Thank you for the reply, but I must admit that I feel that the contents of my previous review rather got confirmed than refuted. In the following, after a personal introductory remark, I will provide a second, in-depth review of several aspects of the study that will unambiguously demonstrate that key calculations are deficient with the consequence that key parts of the results on pressure lack scientific validity and that likely the temperatures as well are questionable. I will conclude with an incomplete list of answers to the authors rebuttal on points where I find that it may be beneficial for clarification.

### ***Additional Review***

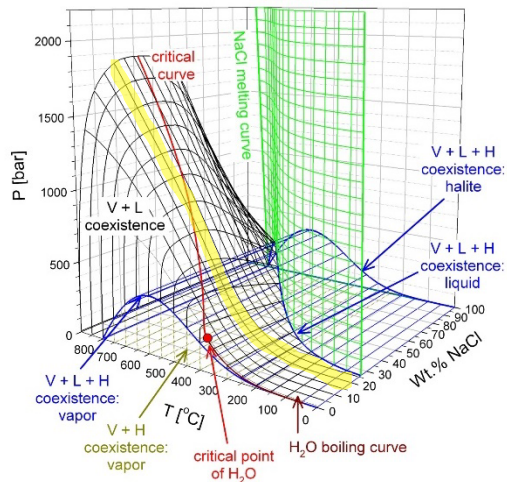
Let’s start with the issue of 21% vapor-saturated brine with the diagram by Driesner and Heinrich (GCA, 2007). I have highlighted the 20 wt.% curve (let’s stay with that as a convenient proxy for the author’s choice for rest of the discussion) in yellow and one can see how it intersects the critical curve at ca. 590 °C, i.e., at lower temperatures it is on the liquid side of the twophase vapor+liquid surface, at higher temperatures on the vapor side. So, there is no such thing as a 20 wt% saturated liquid at temperatures higher than this. One might now argue “ok, let’s simply take a higher salinity such as 33.5% used elsewhere in the manuscript and the problem is gone”.

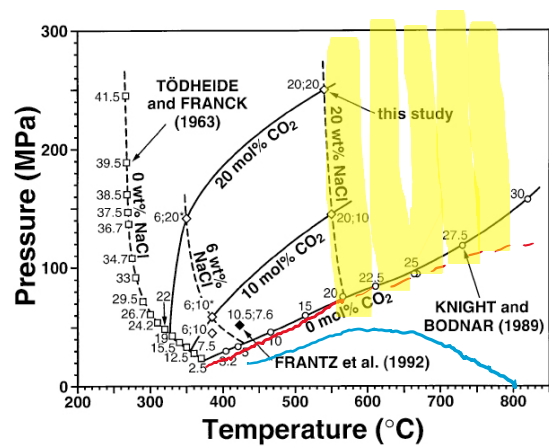
Well, before we come to that point let's first look at a relevant P-T projection of parts of the H<sub>2</sub>O-NaCl-CO<sub>2</sub> phase diagram, taken from Schmidt and Bodnar (GCA, 2000). The most relevant feature in that diagram is the near-vertical line labeled "20 wt% NaCl". This is the critical line for the pseudo-binary "20 wt% NaCl/80wt% water + CO<sub>2</sub>". At temperatures higher than that curve any fluid in the ternary H<sub>2</sub>O-NaCl-CO<sub>2</sub> system that has a 20:80 wt% ratio of NaCl and water and has some CO<sub>2</sub> content will exist as a single-phase, "supercritical" fluid (highlighted yellow, extent to bottom not well known and not well understood). Red added curve is the approximate location of 20 wt% NaCl on V+L surface (solid curve: liquid, dashed curve: vapor), added blue curve is threephase vapor+liquid+halite, both in the H<sub>2</sub>O-NaCl binary. In that binary, below the dashed red curve, there would be liquid with >20% NaCl in coexistence with a vapor <20% NaCl but no fluid phase with 20wt% can exist there. What happens below the red curve in the ternary is not well known, in particular if and where it comes to halite saturation as that is now a divariant surface in T-P rather than a univariant curve and may actually start at much higher pressures than in the binary (see, e.g., Anovitz et al., GCA, 2004).

*I think it is obvious from the above that the authors' pressure calculation method has no foundation at temperatures above ca. 590 °C and that, therefore, **the pressure calculations for the deep reservoir are simply invalid.** An additional, very important point now is that, at the higher temperature conditions, appreciable amounts of NaCl would be present in the vapor phase (in different concentrations for different T-P) rendering the used Peng-Robinson e.o.s. version non-applicable. For example, already at 500°C and 500 bar, Anovitz et al. (GCA, 2004) found up to several mole percent NaCl in the vapor and this should be expected to increase with higher temperature for the simple thermodynamic requirement that it needs to converge with the aqueous liquid's concentration towards the upper critical end curve. **Therefore, even the thermometry is seriously questionable for temperatures of the late part of the time series for the middle reservoir and for all temperatures of the deep reservoir.***

In terms of the manuscript’s main results this means graphically:

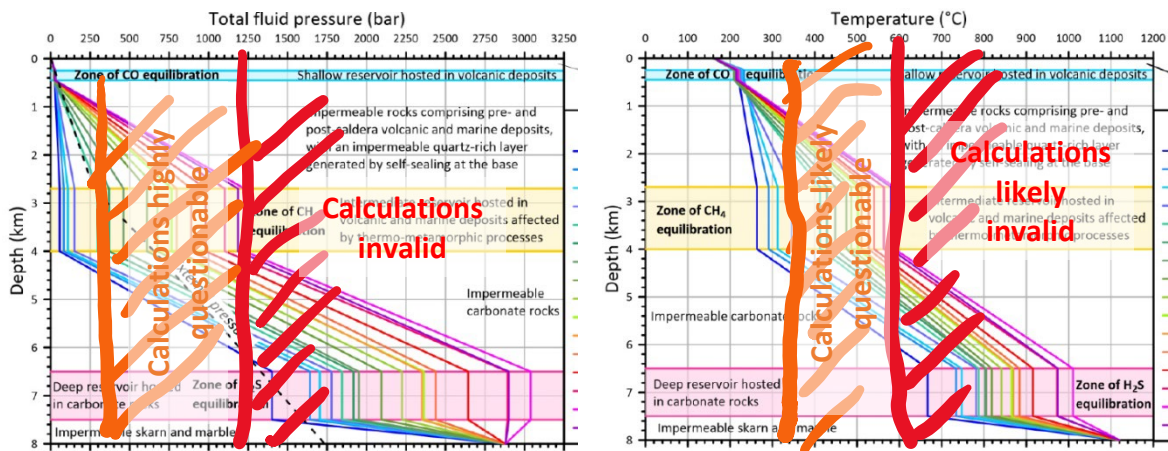
To add on this: the authors could have suspected a serious problem already from their pressure diagram. Fluid pressures as high as 2.4 times lithostatic (or, in absolute values overpressured by up to 1800 bar) and fluid pressure gradients similarly excessive, in particularly in the hot, ductile regime, would be considered unrealistic by many (if not most) people dealing with such problems for reasons laid out, e.g., by Cox (Geofluids, 2010) or discussed in the Weis et al. (2012) paper (or follow-ups on that) that the authors considered not relevant in their rebuttal. In essence, (ductile) rocks cannot sustain such high fluid overpressure, the values are very unrealistic. Since a lot of the implications of the model hinge on that, the author may want to acquaint themselves more with rock failure related to fluid pressure (the Cox paper is a good introduction).
